Item ID: D350-794-141 Accept ***N900040100*** Setup Start ***NS1***
 Revision ID: Stop ***NS2***
 Item Name: Aux Tank Assembly
 Start Date: 7/15/14 Start Qty: 1.00 ***1*** Cust Item ID:
 Required Date: 7/15/14 Req'd Qty: 1.00 ***1*** Customer:
 Reference:

DART SERVICE INSTRUCTION

TO AMEND INSTRUCTIONS FOR CONTINUED AIRWORTHINESS

ICA-D350-794 REV. 8 OR EARLIER
REF. TCCA STC: SH05-4
REF. FAA STC: SR02794NY
REF. EASA STC: 10031514
REF. BRAZIL STC: 2002S09-071-08
REF. AUSTRALIAN STC: ASR063SY

Revise ICA-D350-794 Figure 28-2 and Figure 28-3 as follows:

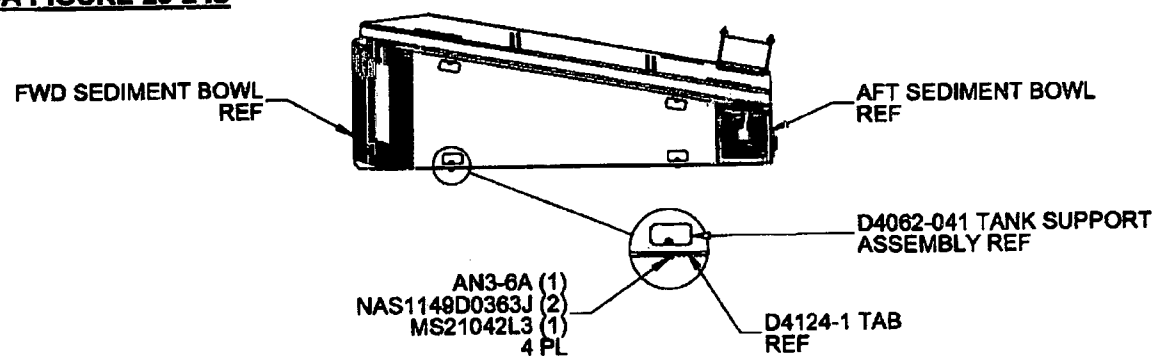
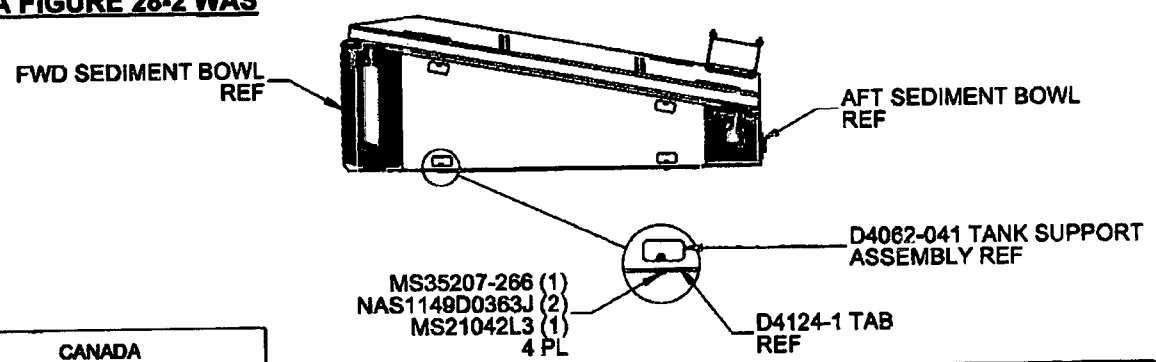
The purpose of this Dart Service Instruction is to amend hardware changes to tank assembly D350-794-141 at change 002 and subsequent.
The NAS1149D0363J washers under the AN3H5A bolts have been replaced by NAS1149D0332J washers to allow greater thread grip. The MS35207-266 screws have been replaced by AN3-6A bolts to prevent the screw heads from becoming stripped during installation.

ICA FIGURE 28-2 IS

ICA FIGURE 28-2 WAS
